**MONTGOMERY COUNTY HISTORIC PRESERVATION COMMISSION**  
**STAFF REPORT**

<b>Address:</b>	7019 Poplar Ave., Takoma Park	<b>Meeting Date:</b>	6/13/2018
<b>Resource:</b>	Contributing Resource (Takoma Park Historic District)	<b>Report Date:</b>	6/6/2018
<b>Applicant:</b>	Rasanjali Wickrema (Paul Treseder, Architect)	<b>Public Notice:</b>	5/30/2018
<b>Review:</b>	HAWP	<b>Tax Credit:</b>	No
<b>Case Number:</b>	37/03-18UU	<b>Staff:</b>	Michael Kyne
<b>PROPOSAL:</b>	2 <sup>nd</sup> -Story Expansion

WEST ELEVATION (FRONT)

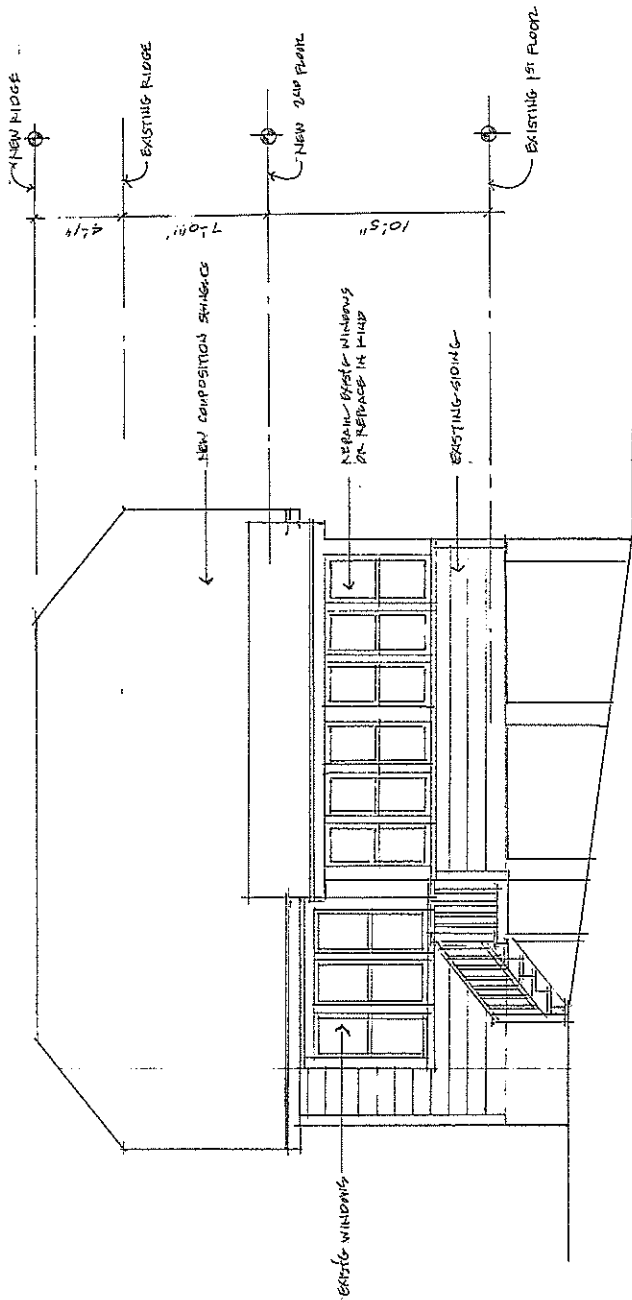
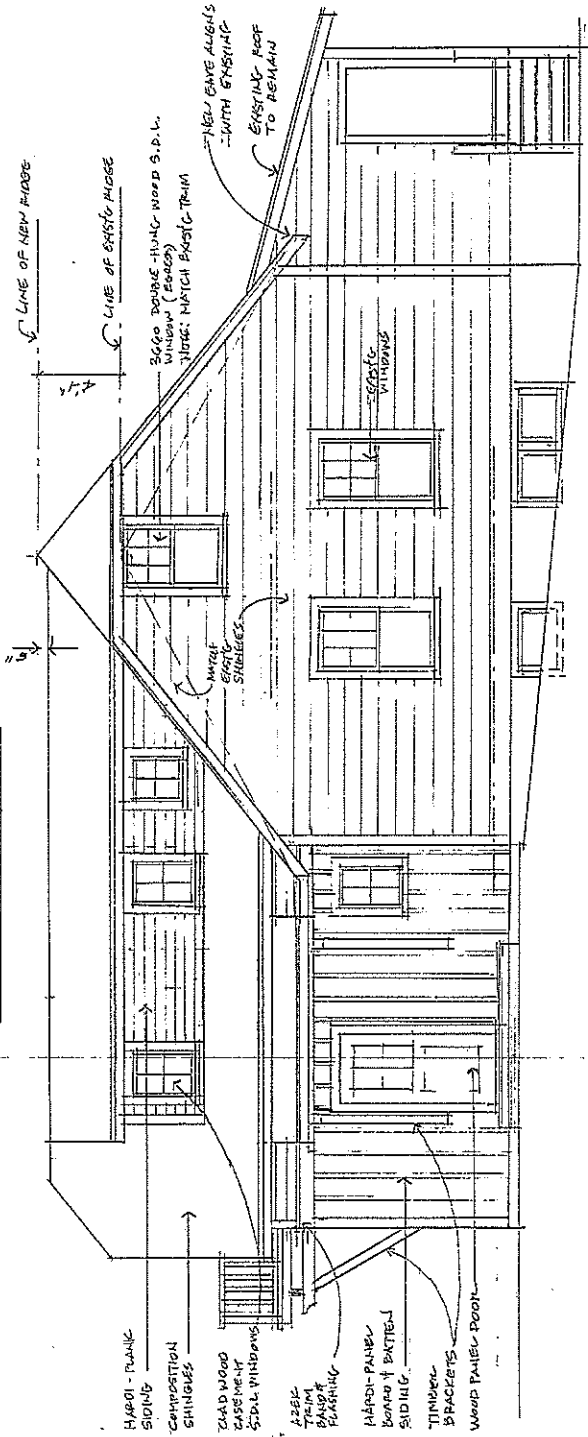
Per Scheme C, the applicant proposed to increase the pitch of the historic house's roof, adding 3' of height while retaining the relationship of the eaves to the windows and other features on the front elevation. As noted, a second-story expansion was also proposed for the previously approved one-story rear addition. Several Commissioners expressed reservations about removing the central chimney from the historic house, but the majority (five of seven) stated that they were not concerned about the proposed chimney removal.

The applicant has revised their proposal consistent with Scheme C and returned for a HAWP application. Staff notes that the applicant now proposes to raise the roof of the historic house by 4' as opposed to the 3' presented at the May 9, 2018 preliminary consultation. Staff finds that the proposal is still generally consistent with Scheme C, and that the additional 1' of roof height does not significantly alter the proposal that was supported by the Commission because the relationship of the eaves to the character-

defining features of the façade will still be maintained to a large degree.

Staff fully supports the applicant's proposal, finding it consistent with the *Guidelines* and *Standards*. The proposed 2<sup>nd</sup>-story expansion is generally consistent with the predominant architectural style of the historic house and will not remove or alter character-defining features of the subject property or surrounding streetscape.
